Access Compliance Report

Public Rights-of-Way

(Pedestrian Signals)

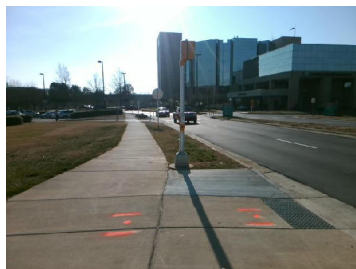
Possible Solutions: Remove & Replace
Replace APS Button With New APS Button.
Remove and Replace Clear Space.

PROW/ADA: R404.7.3, R404.7.2, R209.1,
MUTCD 4e.10
